## **Section 75W Modification (MP 06\_0309) MOD 3**

### **Further Preferred Project Report**

### **Proposed Trinity Point Helipad**

May 2019

**Figure 1 - Proposed Exclusion Area and Designated Take-Off and Landing Area**

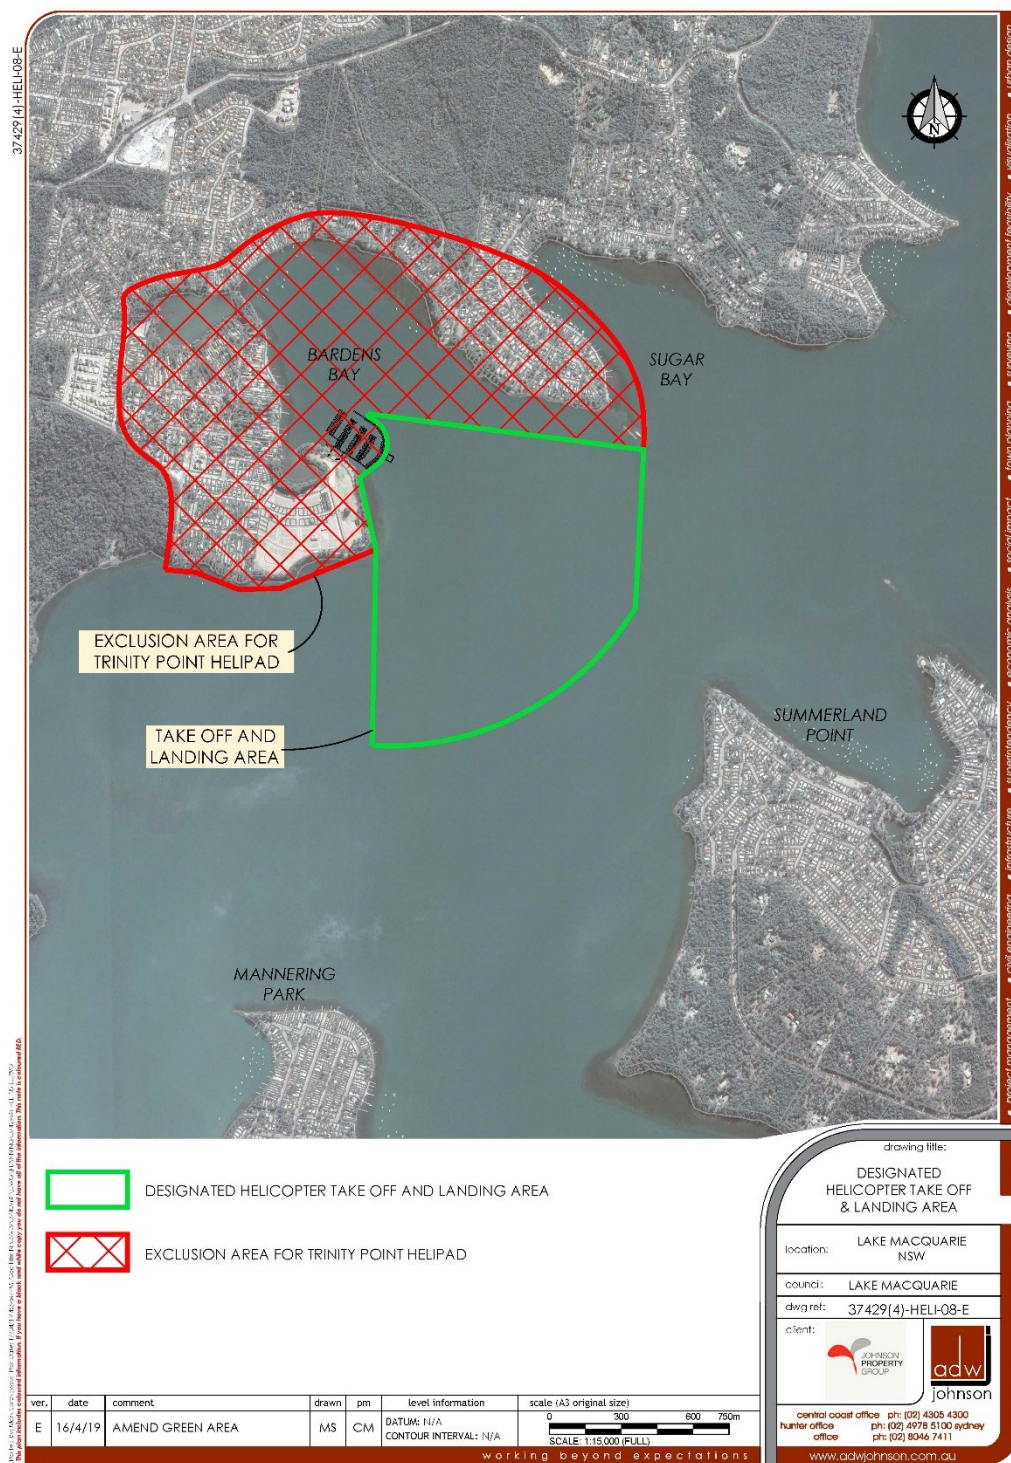
- Helicopter movements to be restricted over residential area of Bardens Bay and part of Sugar Bay, identified as an “exclusion area” for all helicopters (at any height) using the helipad;

- Specific flight paths have been removed and a take-off and landing area (for movements over water below 500 feet) provided to the south and east of the helipad over water;

- No helicopters using the helipad are to fly within the exclusion area (at any height). For the avoidance of doubt, helicopters that are not using the Trinity Point Helipad are not excluded from flying in the exclusion area; and
- All helicopters must land and take-off (ie operate below 500 feet) within the designated

take off and landing area (generally being 1200m from the helipad for movements over water below 500 feet, other than the eastern extent which has been limited to less than 1200m distance to match an existing observable feature within the lake and as assessed by specialists).

Figure 2 - Proposed Helipad.

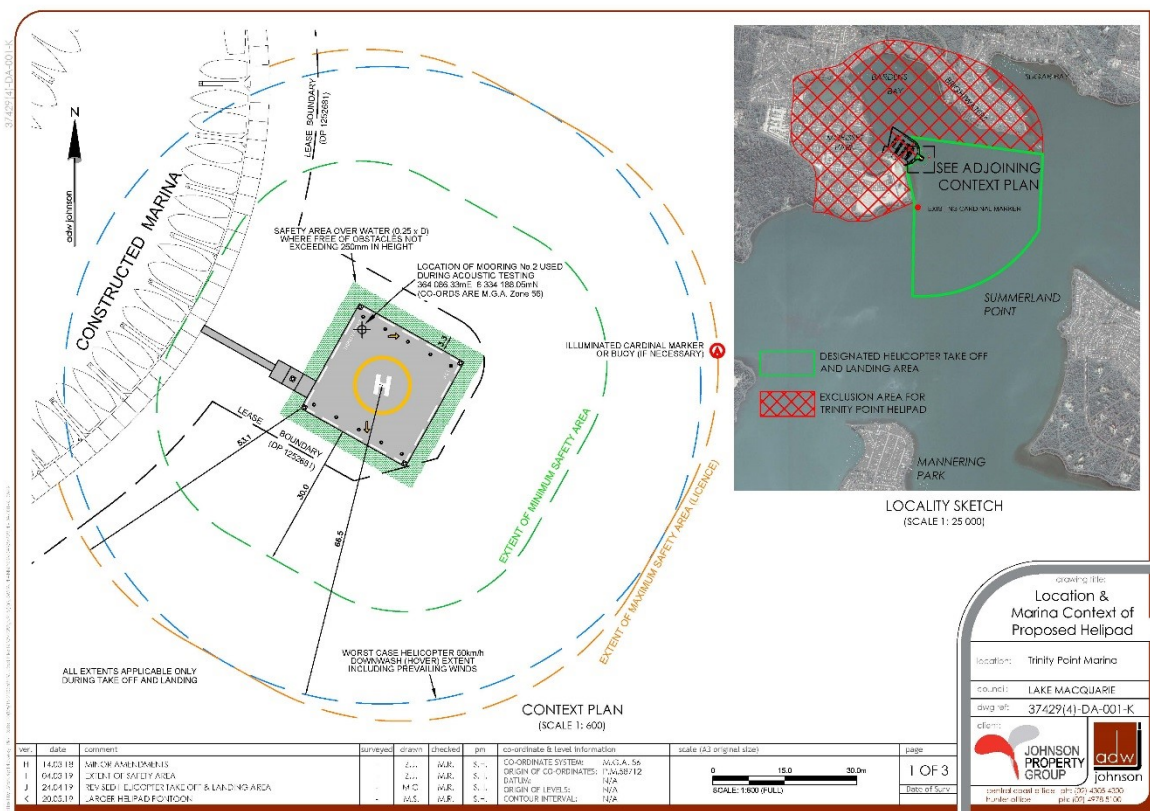
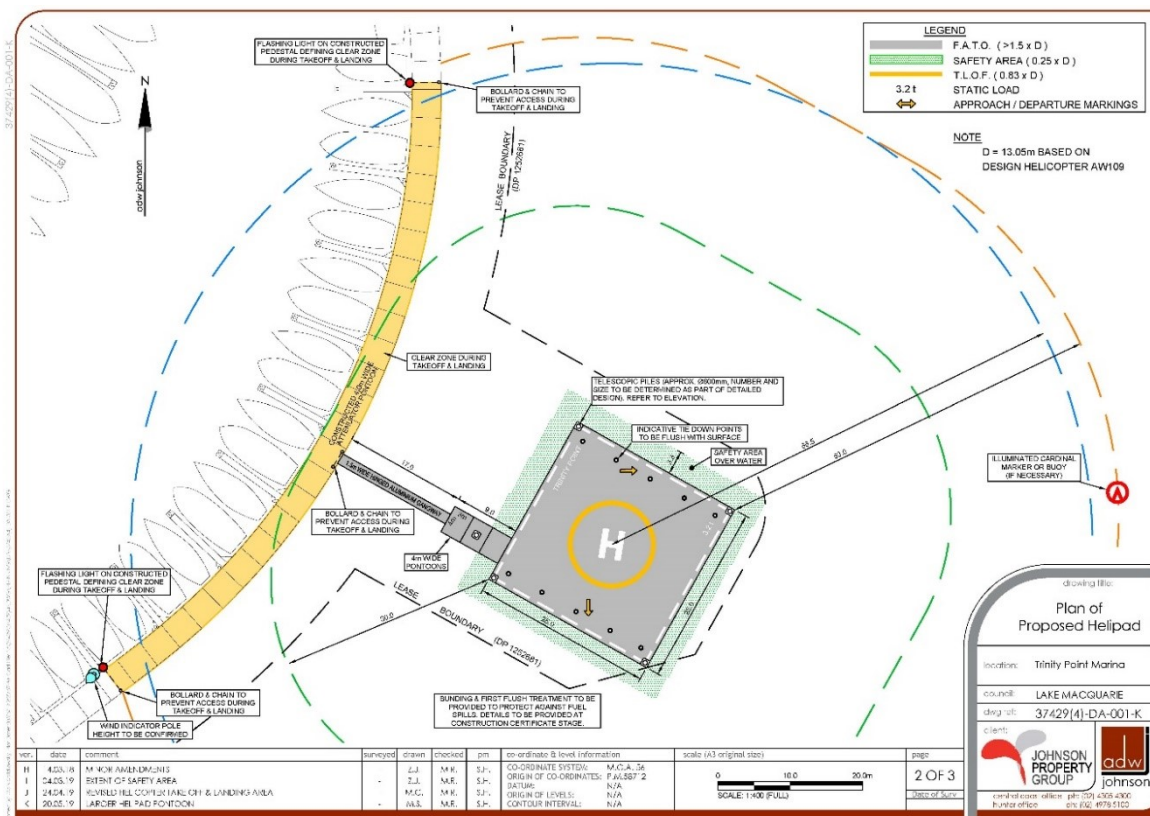
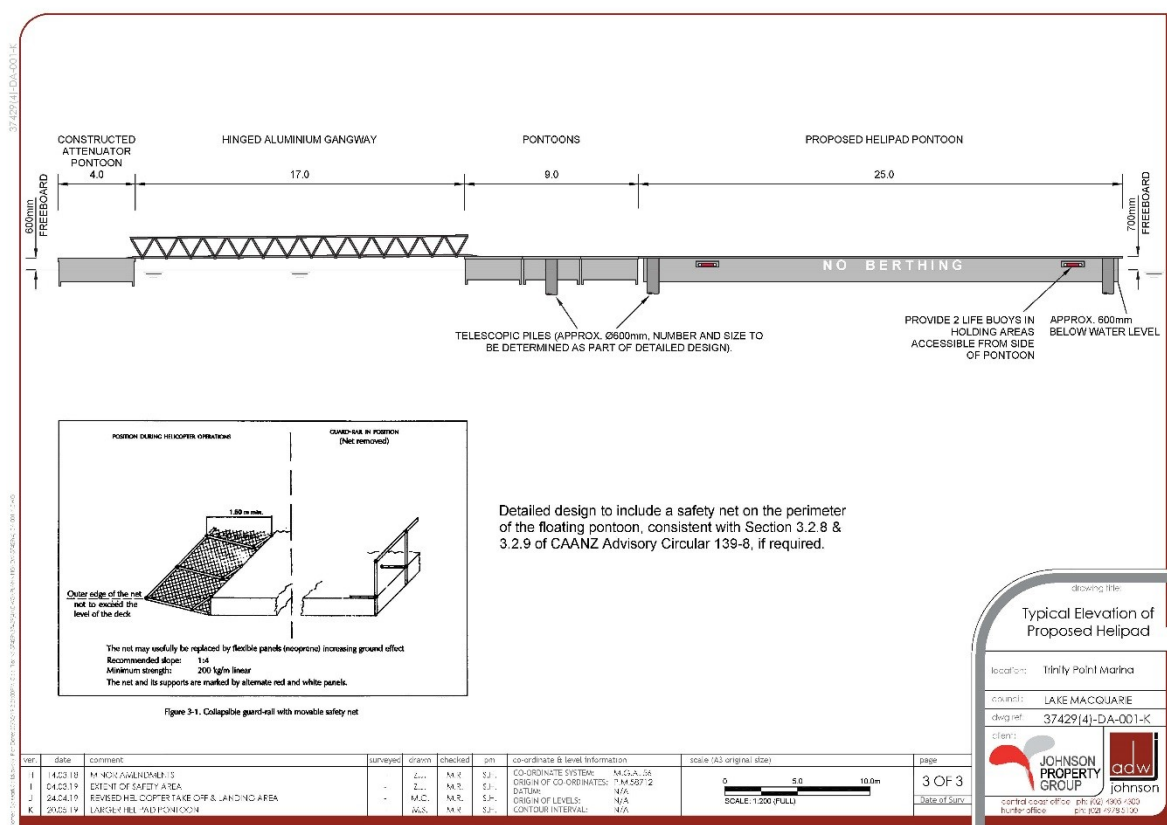
- The size of the helipad pontoon has been increased to 25m x 25m (without change to the design helicopter) with a minor shift in location of the centre of the helipad and to the minimum 30m managed safety zone, to reflect that change;

- The pontoon design remains based on the Agusta Westland AW109 as the design helicopter, as described within the previous environmental assessment reporting, other than the pontoon size has increased;
- A 25m x 25m pontoon (which exceeds the minimum 20m x 20m FATO required for the design helicopter) with at least 4 x corner telescopic piles will be constructed. The

corner telescopic piles are anticipated to be 600mm diameter. The number of piles, diameter and design will be subject to detailed design. The piles will not extend above the pontoon so as not to present a safety hazard during helicopter movement, and their installation does not require dredging;

- The pontoon will be connected to the marina by a 1.5m wide x 17m long gangway and three, 3m x 4m pontoons, with one pile. In accordance with Civil Aviation Safety Authority (CASA) guidelines, the pontoons will not contain a handrail. If during detailed design it is determined by a qualified aviation consultant that a safety net is a desirable addition to the helipad, this can be provided, and has been notated on the plans;

- The helipad pontoon will sit in the water similar to the marina outer breakwater structure. Preliminary engineering identifies that the helipad will sit 700mm above water level with 600mm draught below water level;
